Bill Egan, P.E.
Chief Civil Engineer, Dept. of Public
Works
City Hall Plaza, Room 710
Boston, MA 02201

Re: Connect historic Boston project

Causeway Street, December 17 presentation

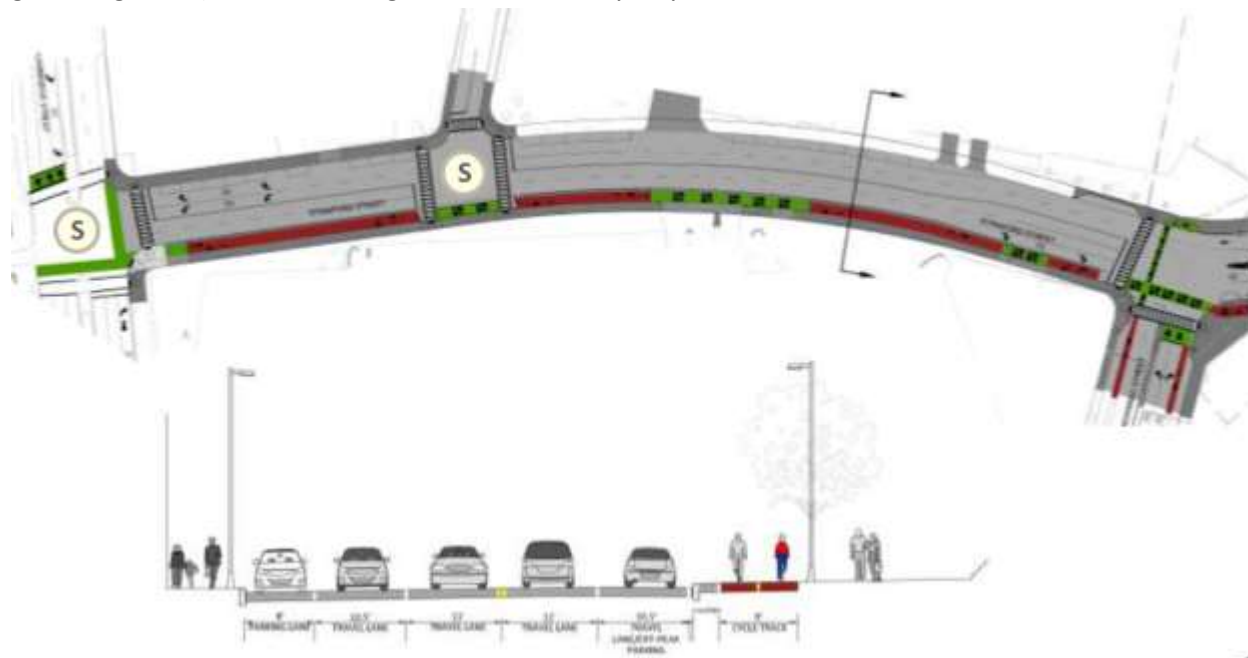
On **page 14** we see claims to

- Design corridor for commuters, residents, employees, and visitors
- Improve pedestrian environment
- Provide family-friendly bicycle facilities
- Support development (existing & proposed)
- Maintain adequate vehicular access
- Retain curbside transit access

“Design corridor for commuters, residents, employees, and visitors” – but primarily, for visitors, as in “family friendly.” For one thing, note that getting to the other side of the street in mid-block is not addressed. This is a trail plan, not a transportation plan.

“Improve pedestrian environment.” The claim appears to be mostly one of beautification and creation of points of interest. The project will decidedly *worsen* safety for pedestrians, by creating a more confusing and complicated traffic pattern. A barrier-separated bikeway in the street corridor, especially if two-way, invariably does this, because the pedestrian must look for bicycle traffic in unexpected directions (e.g., look to the left as well as the right on the near side of the street). We used to call riding

“Maintain vehicular access” – in other words, it will be compromised, but that’s OK as far as the planners are concerned.

“Retain curbside transit access” –this is an *afterthought* at the busy transit hub, North Station.

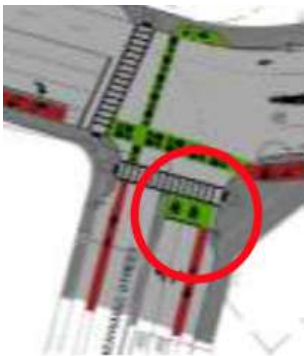
Now let’s look at the plan for Staniford Street (**page 22**). This is to be a 9-foot-wide, two-way, one side of the street bikeway, adjacent to a travel lane, ramping up and down, crossing wide driveways (the three green segments) and connecting to other streets by bicycle crosswalks.

9 feet is substandard, not wide enough to allow overtaking in the face of oncoming bicycle traffic. The Minuteman bikeway, at 12 feet and with grass shoulders, is barely wide enough. Staniford Street slopes down from Cambridge Street and bicyclists headed down the slope will easily travel as fast as 20 miles per hour. The driveways expose bicyclists who arrive from unexpected locations and directions to crossing and turning motor traffic.

At the left side on **page 22**, the intersection with Cambridge Street has westbound bicyclists directed to the sidewalk on the northwest corner. How are they supposed to proceed on Cambridge Street? Swerve out into the street? Ride up onto the sidewalk?

The same intersection has eastbound bicyclists cross in a bicycle crosswalk. Entering an intersection from the right on the near side is wrong-way riding and is highly hazardous because motorists do not look in that direction for traffic at bicycle speeds. This has been demonstrated conclusively in one crash study after another, as far back as the 1970s.

Page 22 also shows the two-way path crossing the end of Merrimac Street in conflict with traffic turning right from Staniford Street and entering from Merrimac Street. At the right side of you also can see one of the “bike boxes” where bicyclists are expected to overtake motor traffic on the right, as in my Charlesgate example discussed at <http://john-s-allen.com/blog/?p=5750>, only this time at the right of a

right-turn lane – a violation of national design guidelines – and then swerve sharply left into the “bike box” to wait for the traffic signal, but not knowing when it will change.. Bike boxes have become the “cookie cutter” solution in Boston when bicyclists need to queue to prepare a left turn or cross from one side to another of a one-way roadway.

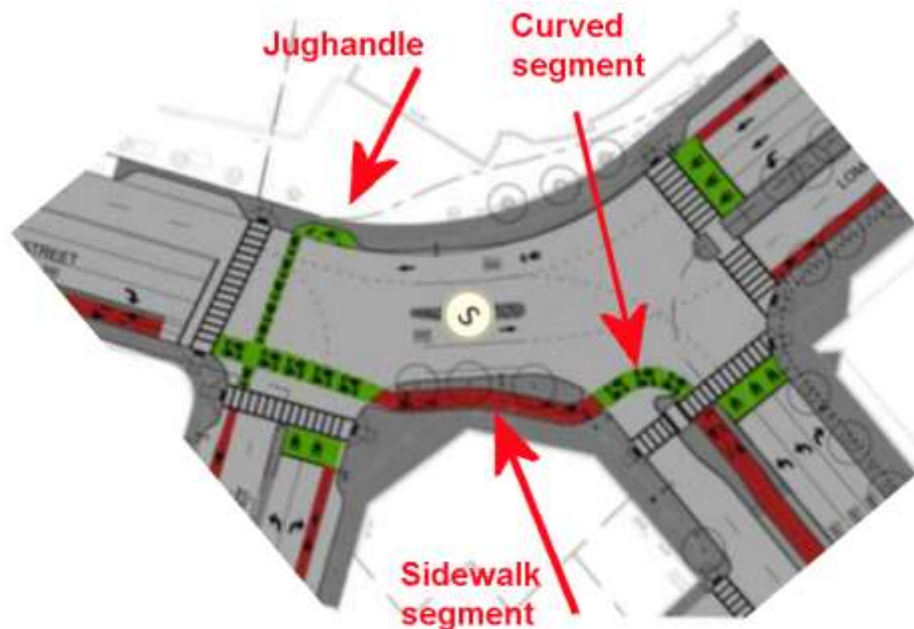
Proceeding to **page 23**, Lowell Square, we see how the bikeway now becomes, outright, a path along the sidewalk between Merrimac Street and Causeway Street, in conflict with pedestrians. Then bicyclists are directed onto an oddly curved two-way on-street bikeway which cuts across the path of right-turning traffic from Staniford Street and left-turning traffic from Lomasney Way Street (upper right in the

picture.) And there are two more bike boxes in this picture. Bicyclists appear suddenly from unexpected

and unusual directions, some of them in motorists' right rear blindspots, others involving unexpected changes in direction.

The bike lanes on Merrimac Street and Nashua Street are the usual narrow Boston door-zone bike lanes. That is, a bicyclist riding at a normal speed in these lanes is defenseless when a

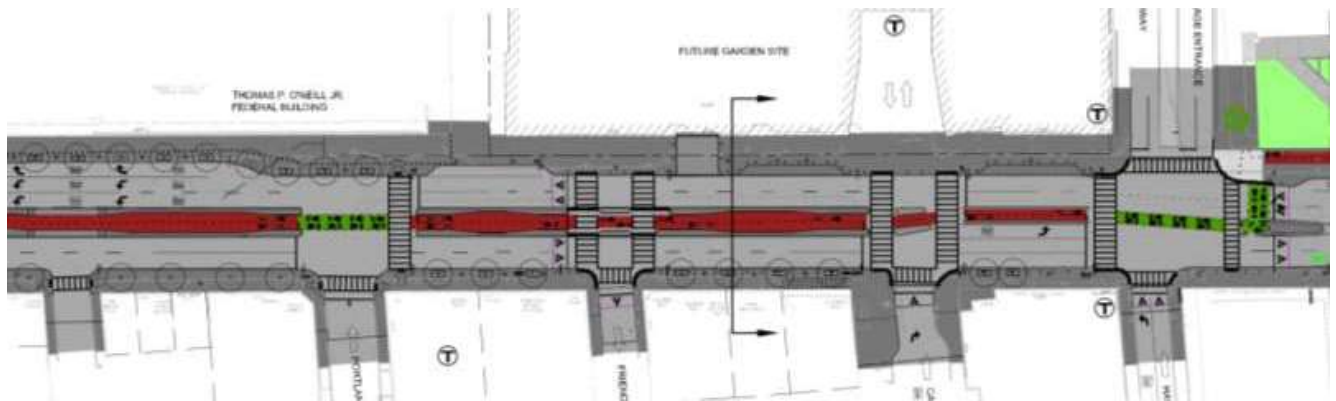
A jughandle as shown on **page 24** attempts to make left turns easier for bicyclists who are not confident to merge to the normal left-turn position. A jughandle is not necessarily a bad idea, but it does necessarily involve compromises in traffic signal timing and a longer, slower route for a left turn. At the jughandle from southbound Massachusetts Avenue to Somerville Avenue in Porter Square in Cambridge,

the green light is very short, and bicyclists invariably encounter a red light at the next intersection, only 100 feet after they turn left. This is a wink and nod to run the red light. Essentially, the bicycle provision was shoehorned into the signal timing. It's simpler and easier just to use the left turn lane.

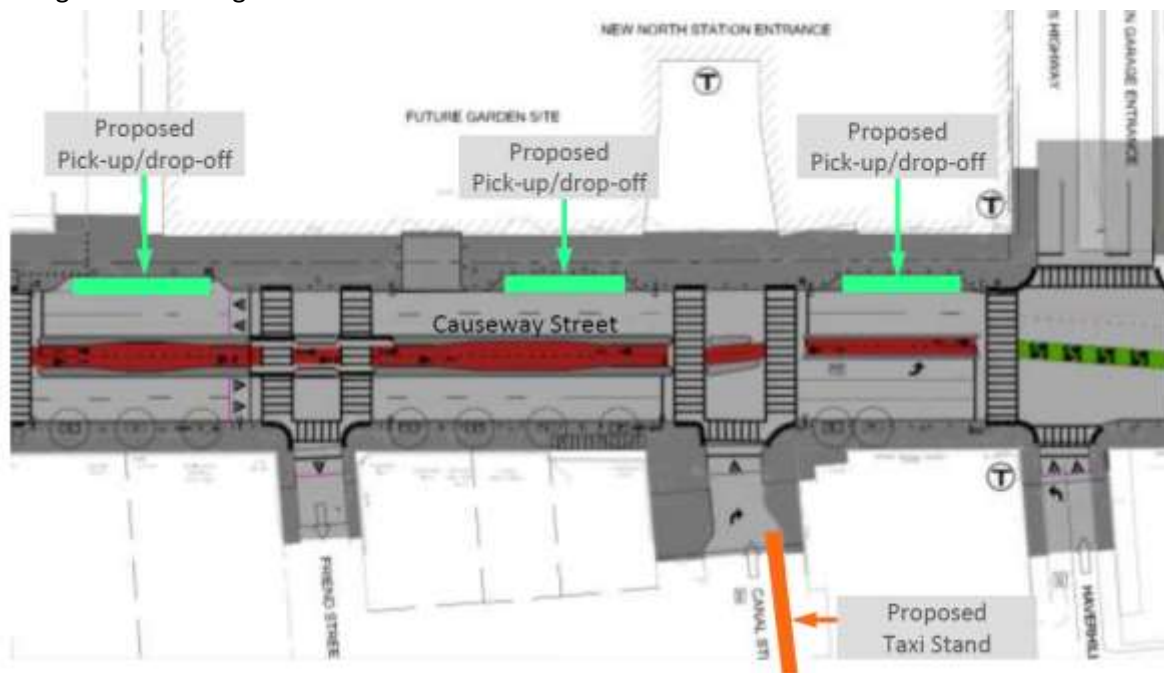
Page 25 shows the design for Causeway Street – a bikeway in the median, between curbs, ramping up and down. The intent of the curbs is to prevent U-turns across the median (except, of course, at Portland Street, where they will be concentrated). These U turns are a problem on Pennsylvania Avenue in Washington, DC, a similar installation without curbs, see

http://wamu.org/news/13/11/08/cycling_advocates_say_not_even_zebras_stopping_u_turns_on_pennsylvania_avenue). On the other hand, the cross-section shown invites puddling, and ice patches in winter. These problems do not occur with a normal, crowned street cross-section.

The distinction between a pedestrian refuge at the median and a bikeway is lost. The left turn to Lancaster Street (leftmost one in the image) is impeded. Bicyclists are expected to wait for a signal, then turn 90 degrees to continue at Beverly Street (right side of picture). Loading zones, taxi stands and bus stops are an afterthought or must be relocated. (See **page 28.**) Where are the many buses which now unload on Causeway Street supposed to go? Why is the very large empty area in front of North Station is to be given over entirely to private development rather than at least in part serving as a bus and taxi loading and unloading area?

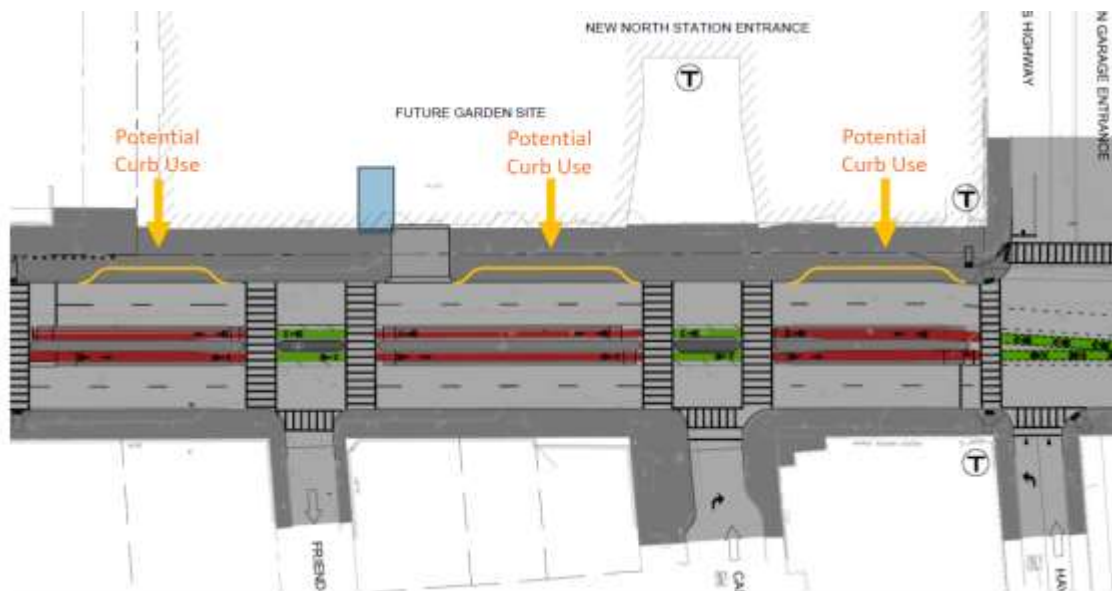
Page 18 – cycle tracks and pedestrians. What is shown at the left is a path along the Hudson River waterfront, not a cycle track. I have a photo of the same location here:

What is shown at the right is a pedestrian refuge, and there are none in the Causeway Street/Staniford Street segment. Also, the image is a Photoshop job. The pedestrians and parked cars have shadows but

the tree, lamppost and flex posts have none. .

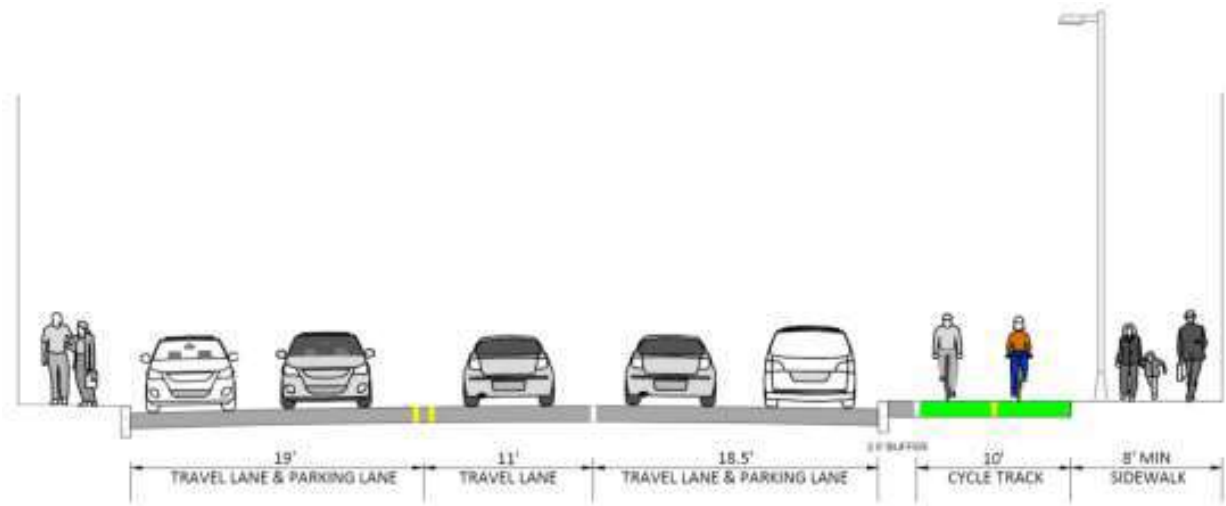
On **page 27**, note that the bikeway on Causeway Street is divided by a median (pedestrian refuge – but where there are no crosswalks?) and the two sides are too narrow for a bicyclist to overtake another. With an up curb on one side and a down curb on the other, there is no way to merge on and off the street. In the later, revised presentation, the bikeway has been widened and the median is gone. It looks as though there was some give and take between bicycle and pedestrian advocates.

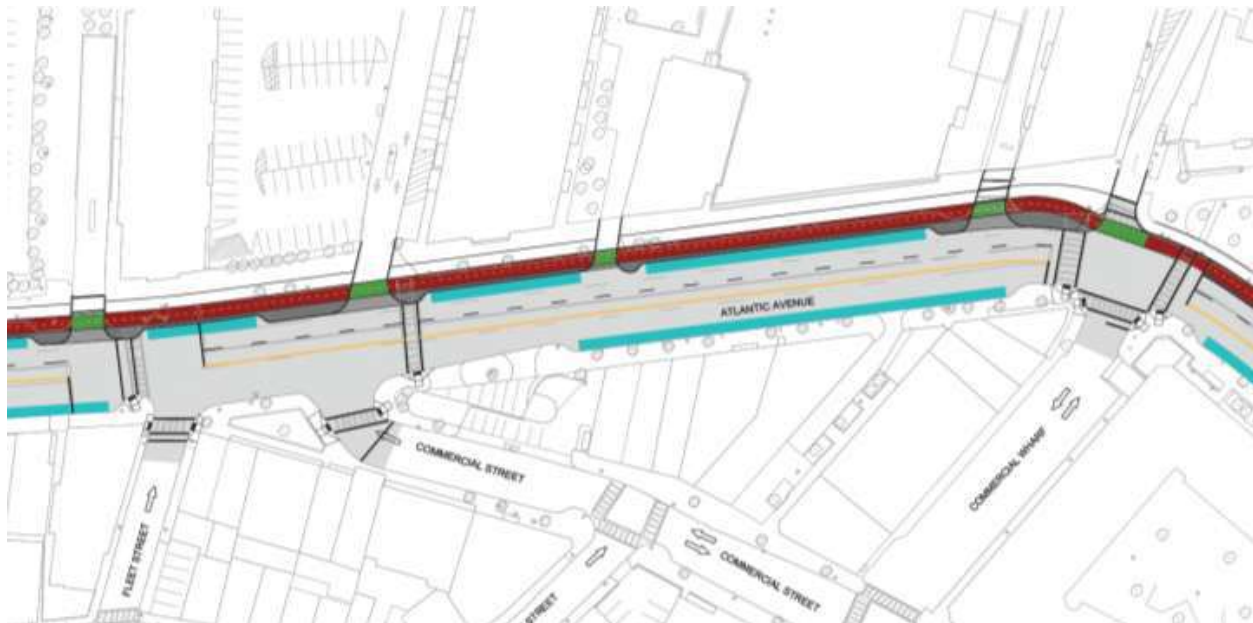
The introductory materials are the same as in the Causeway Street presentation, then **page 20** shows a two-way bikeway in sidewalk space, with a narrowed roadway. The bikeway is nominally 10 feet wide, one foot wider than on Staniford Street.
